**Addendum No. 001**

**Subject: 2020 Classroom Modernizations**  
**SDP Contract Numbers: B-022 C of 19/20 & B-024 C of 19/20**

**Location: Fox Chase School**  
**500 Rhawn St, Philadelphia PA 19111**

2 ELECTRICAL OVERALL GROUND FLOOR PLAN - ELECTRICAL PANEL LOCATION COORDINATION - NEW WORK  
E2.1 3/6" = 1'-0"

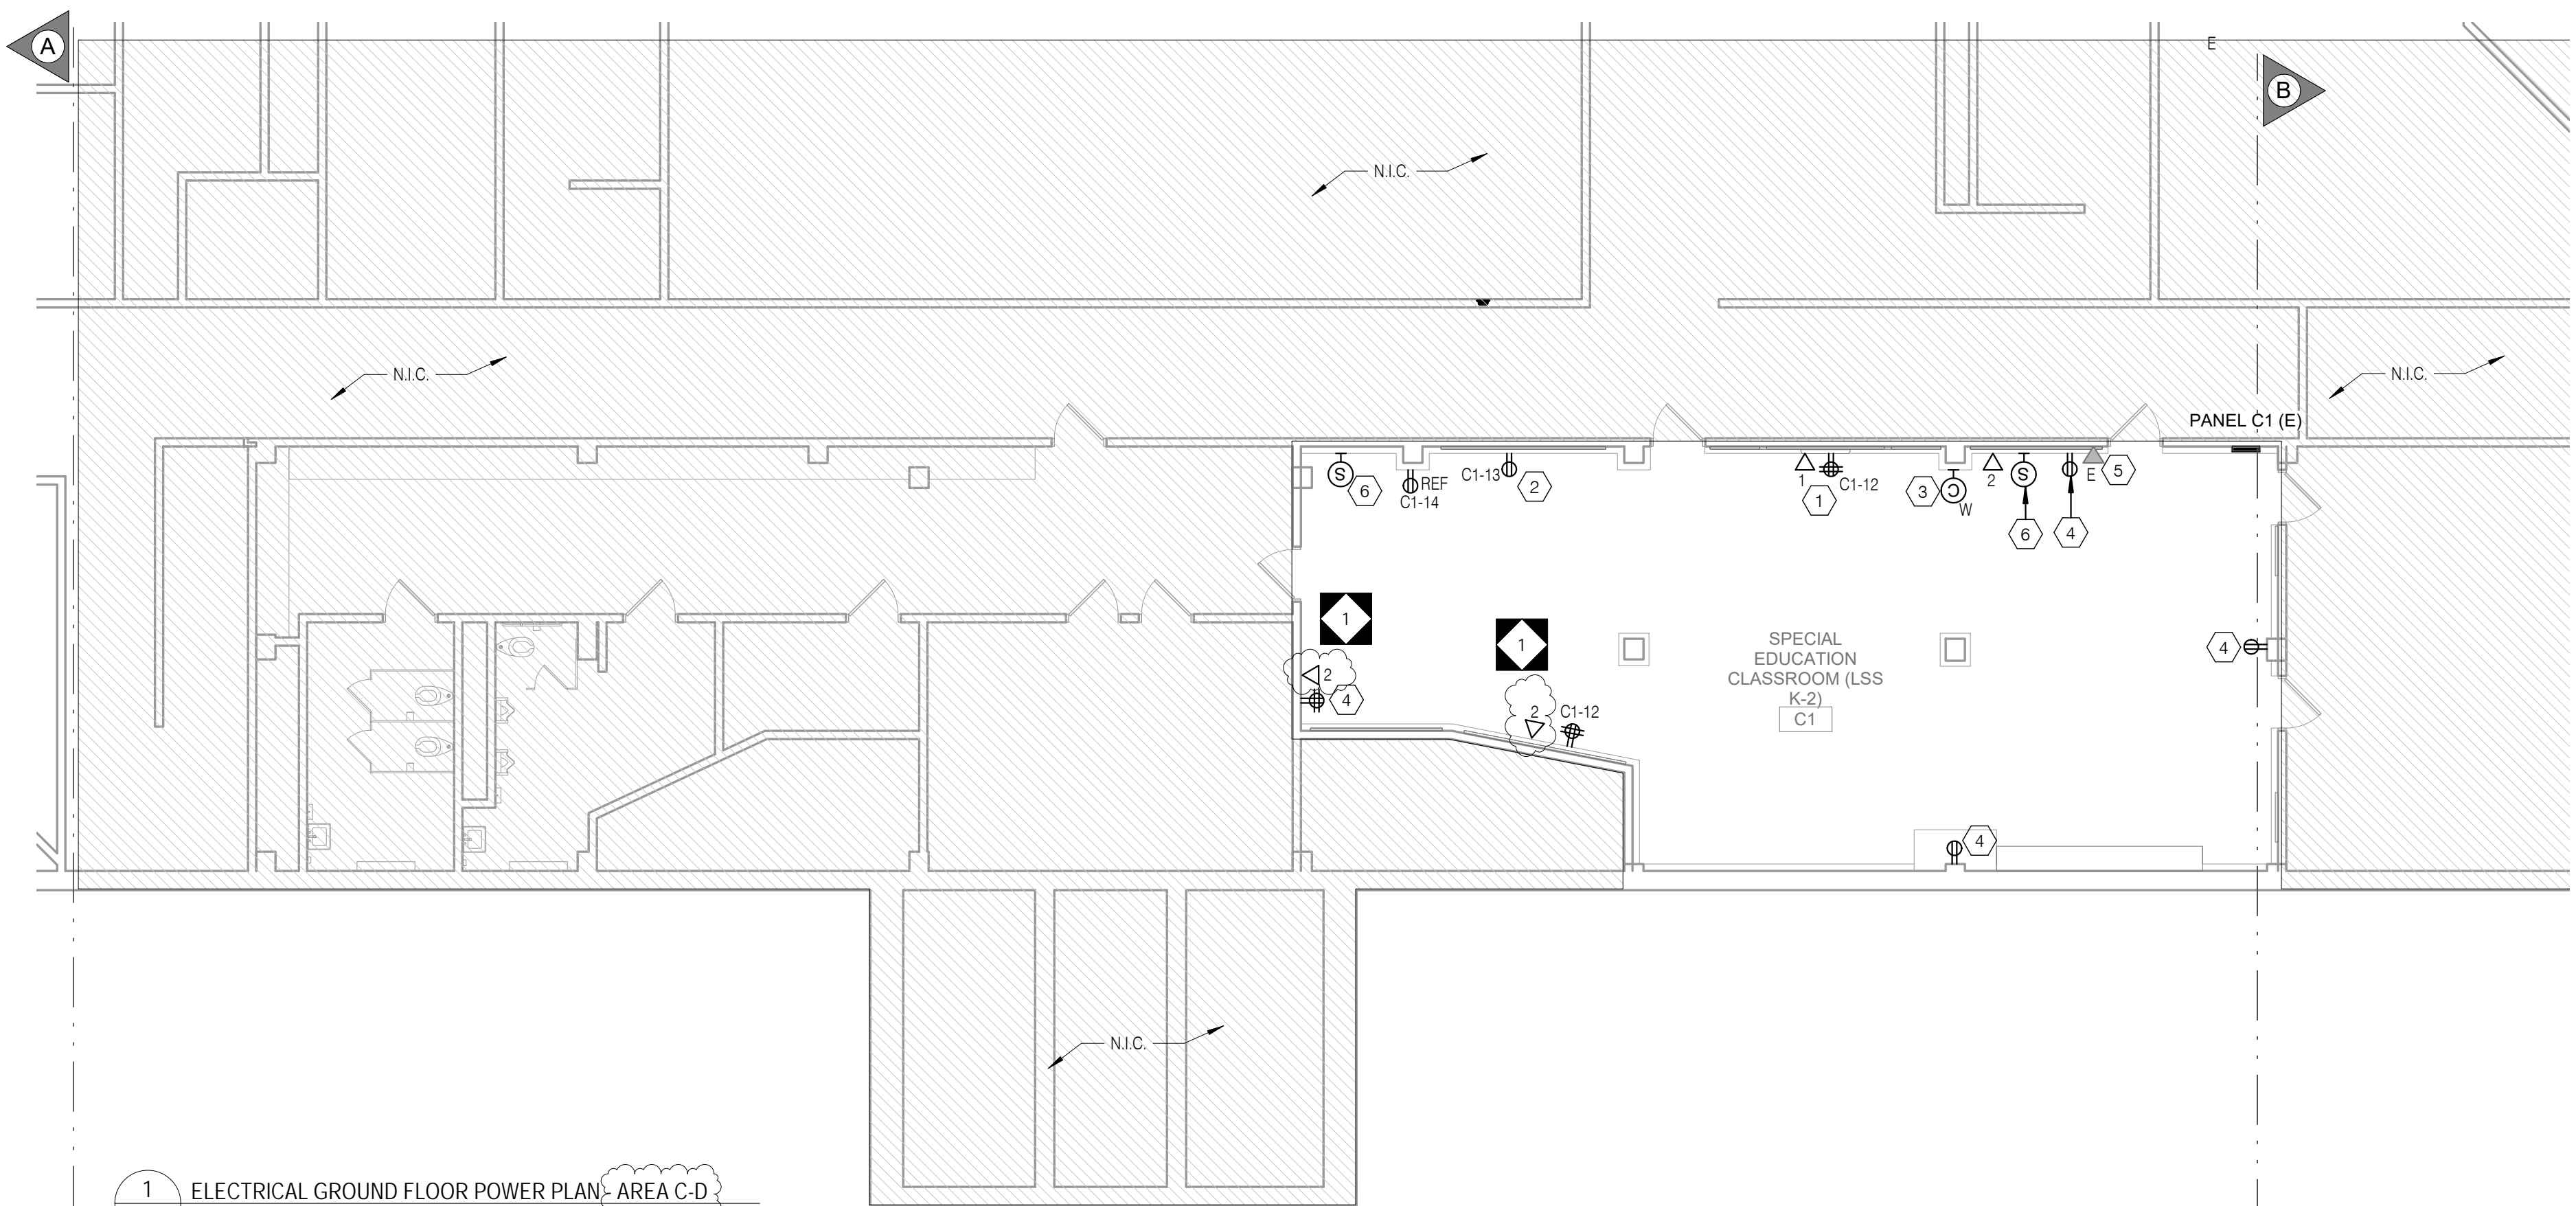
1. REVISE view name for 1/ED1.1 to read "ELECTRICAL GROUND FLOOR POWER PLAN – AREA C-D."
2. ADD 2/ED1.1 ELECTRICAL OVERALL GROUND FLOOR PLAN – ELECTRICAL PANEL LOCATION COORDINATION – NEW WORK, as indicated on the drawings.
3. ADD general sheet note #6 to read "ELECTRICAL CONTRACTOR TO RUN ALL NEW SURFACE MOUNTED CONDUITS AND RACEWAYS IN CORNERS OFF EACH CLASSROOM TO AVOID CONFLICT WITH DISPLAY BOARDS AND OTHER CLASSROOM FURNISHINGS."
4. ADD keyed sheet note #7 as indicated on the drawings.
5. REVISE data outlets as indicated on the drawings.

1 ELECTRICAL FIRST FLOOR POWER AND TECHNOLOGY PLAN - UNIT A-B  
E2.2 1/8" = 1'-0"

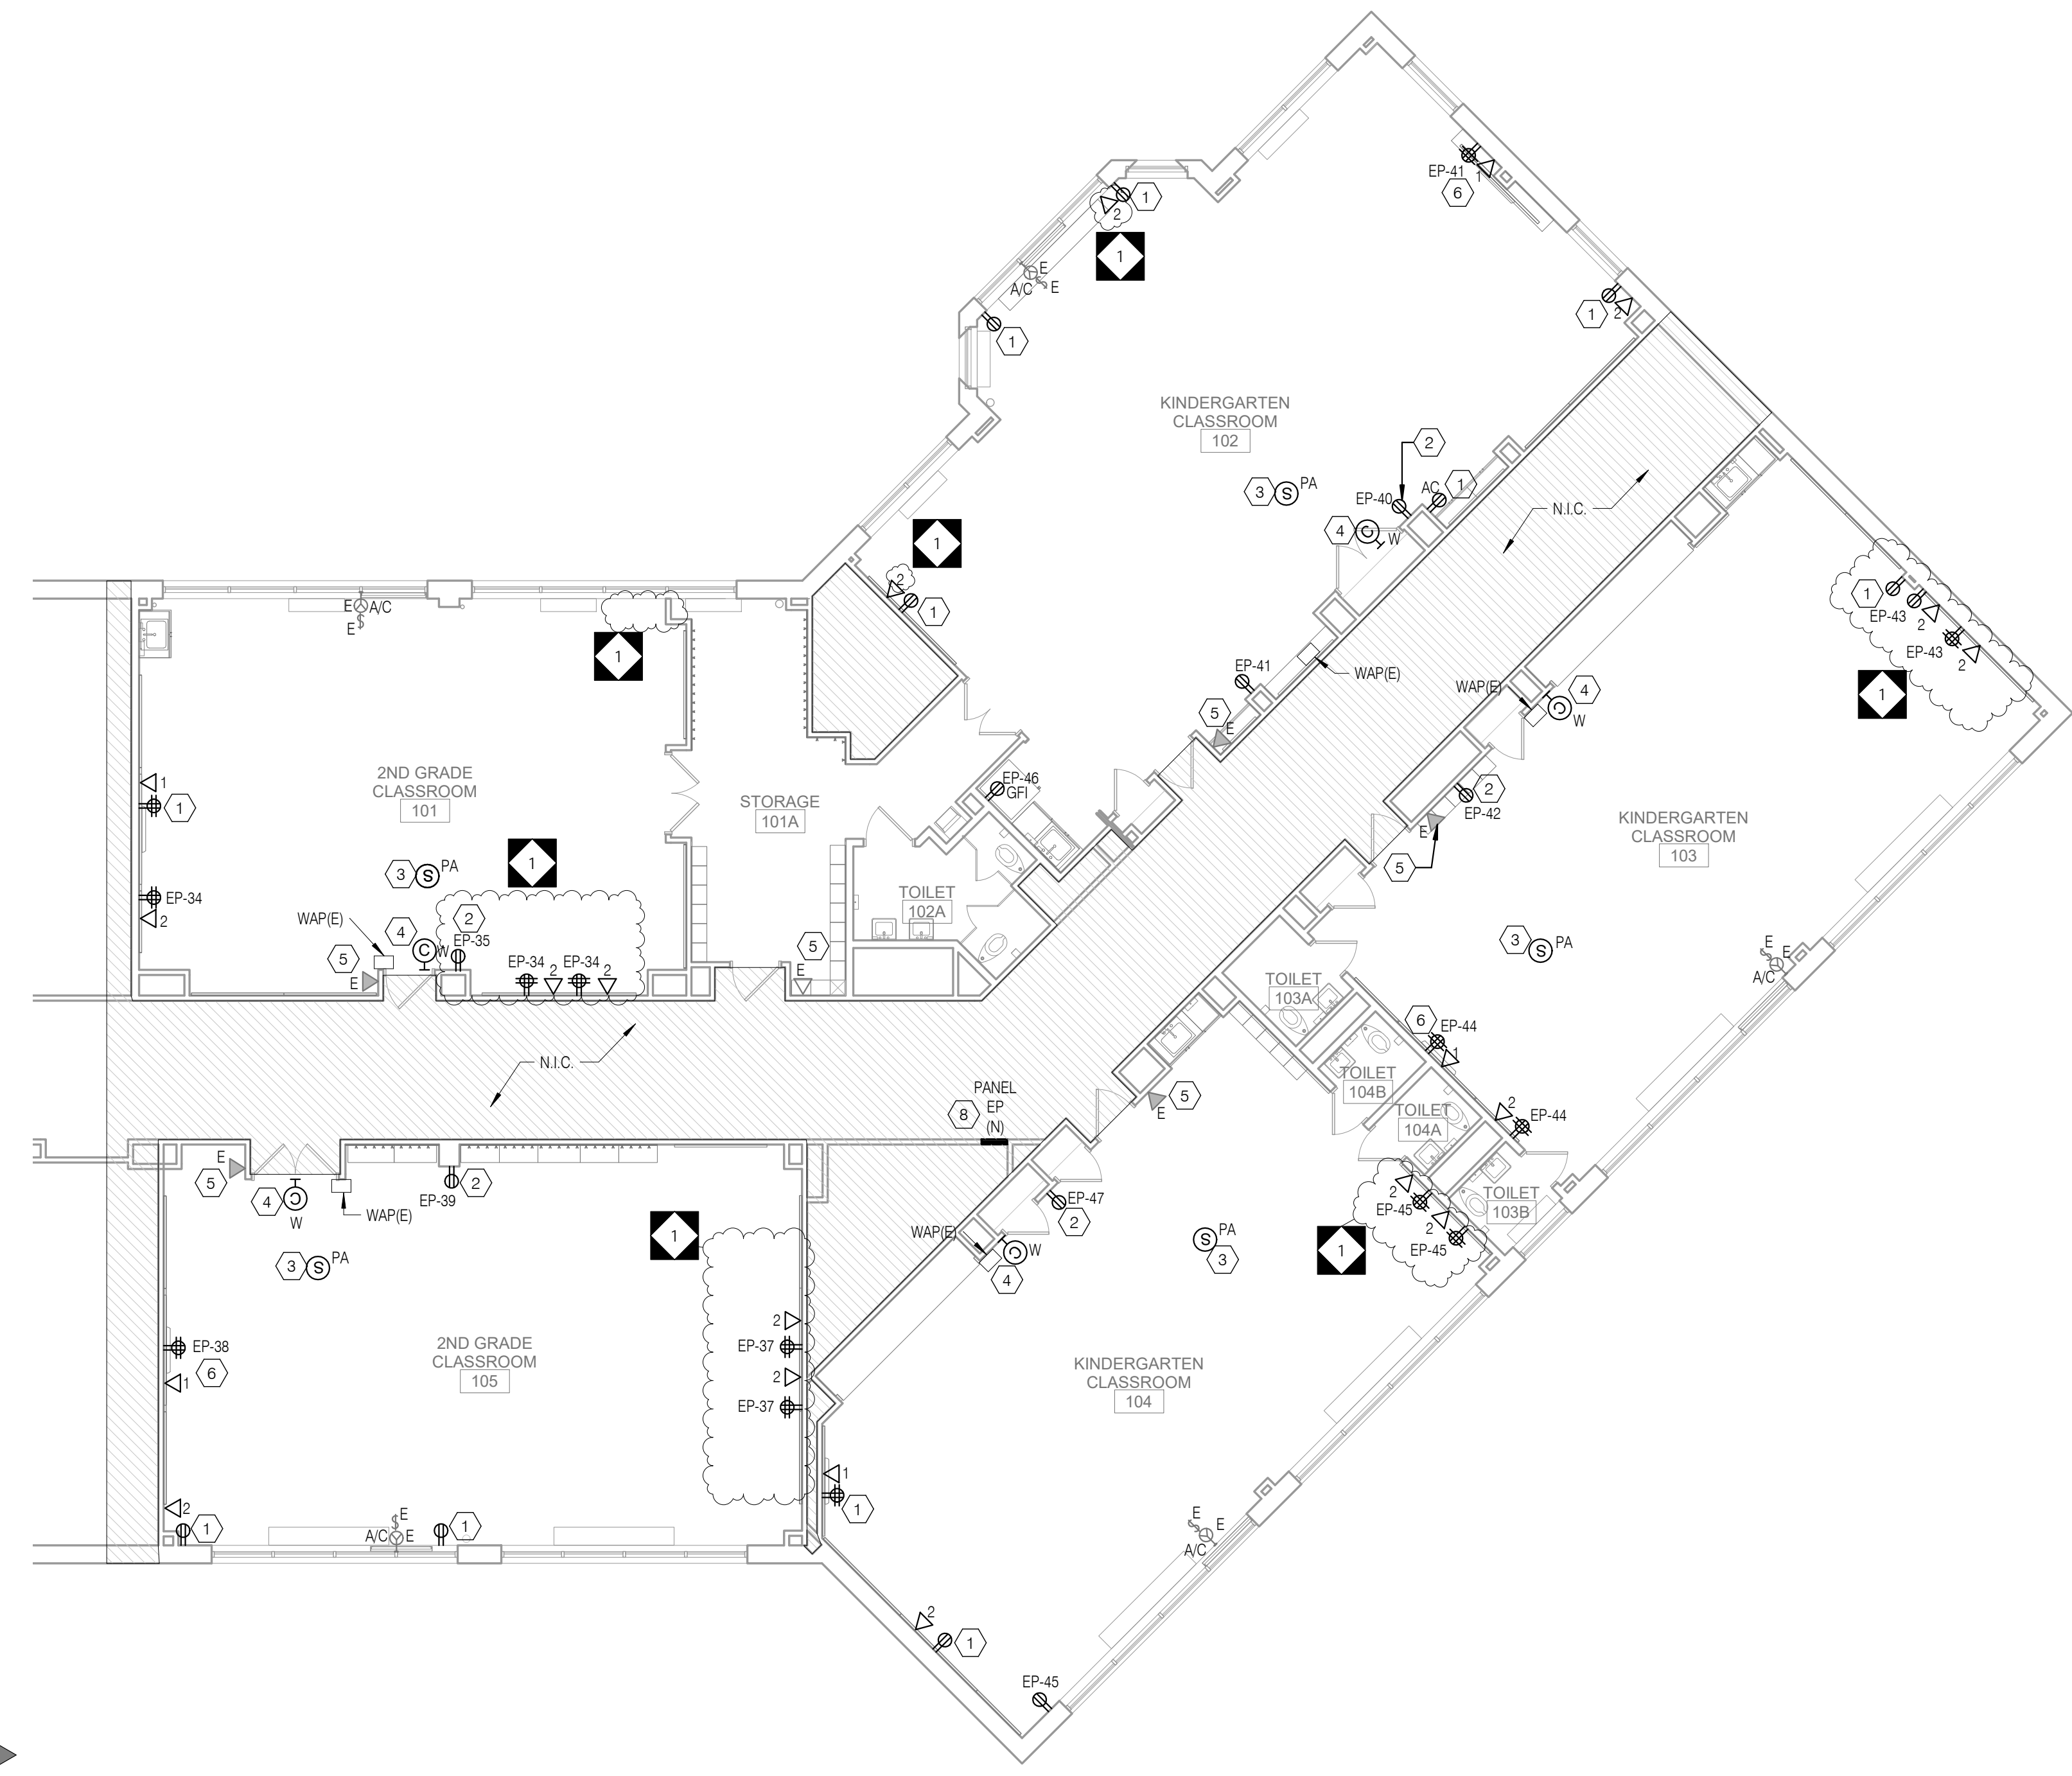
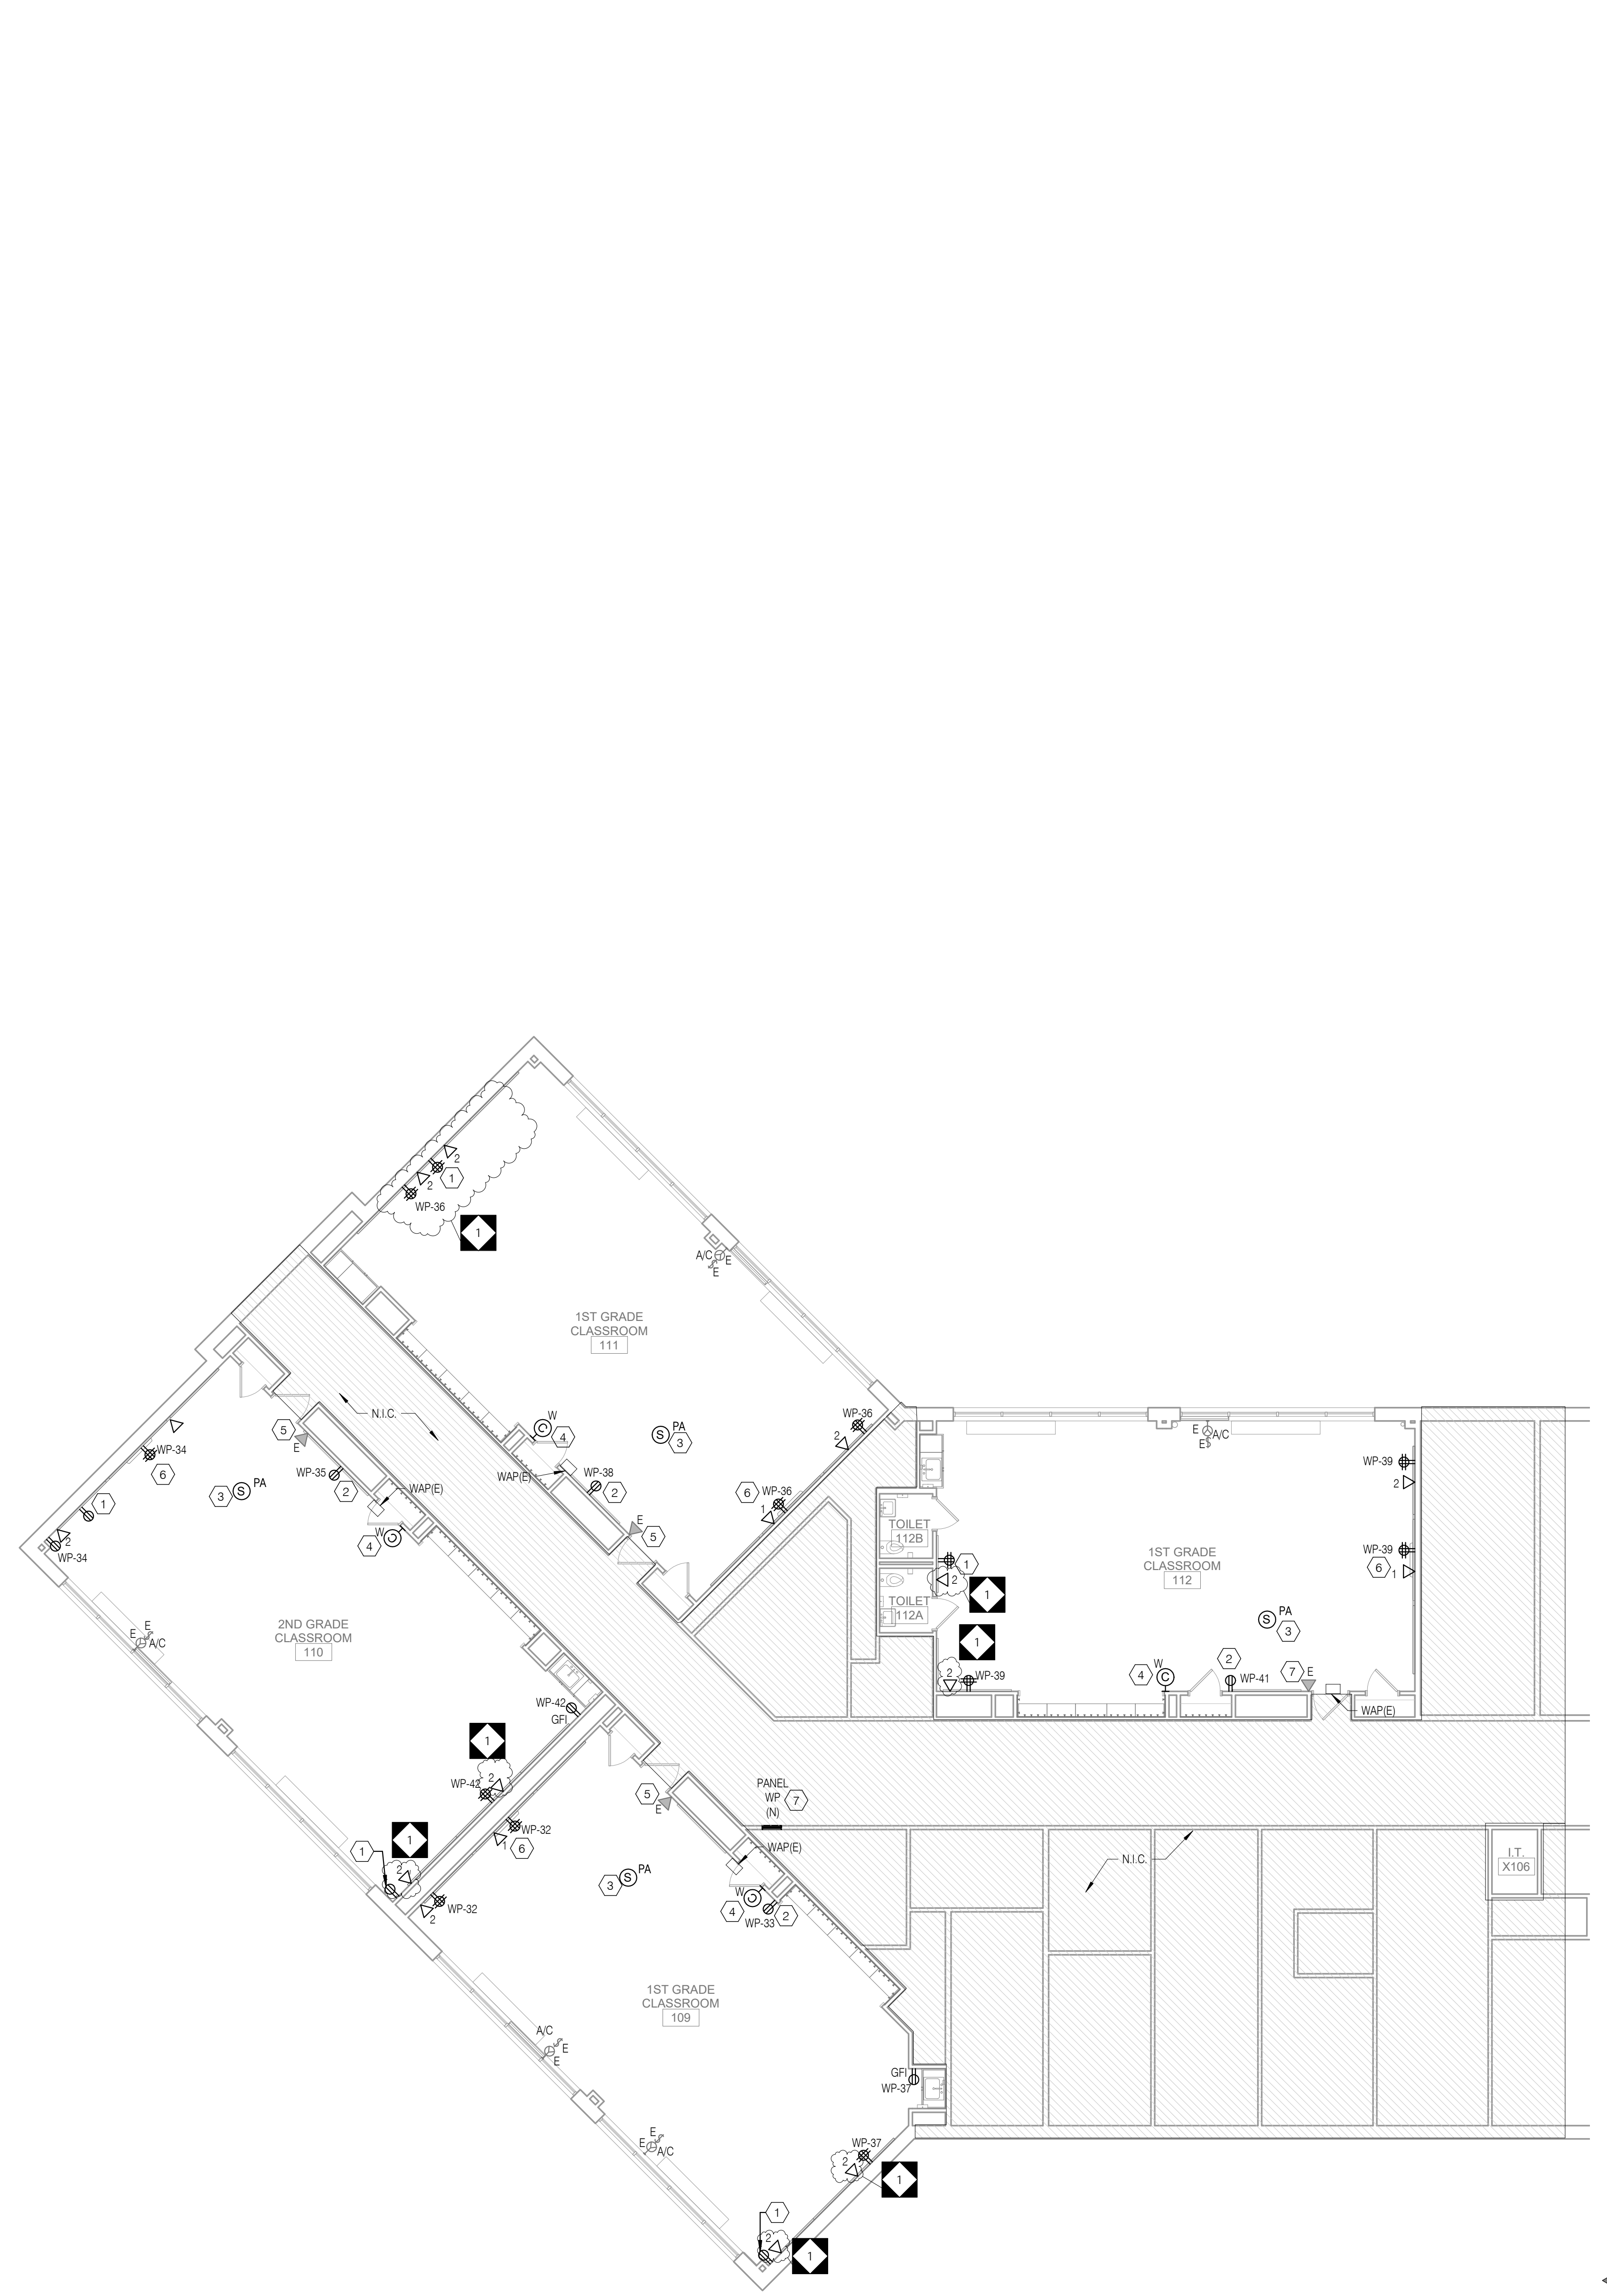
1. ADD general sheet note #6 to read "ELECTRICAL CONTRACTOR TO RUN ALL NEW SURFACE MOUNTED CONDUITS AND RACEWAYS IN CORNERS OFF EACH CLASSROOM TO AVOID CONFLICT WITH DISPLAY BOARDS AND OTHER CLASSROOM FURNISHINGS."
2. REVISE data outlets as indicated on the drawings.
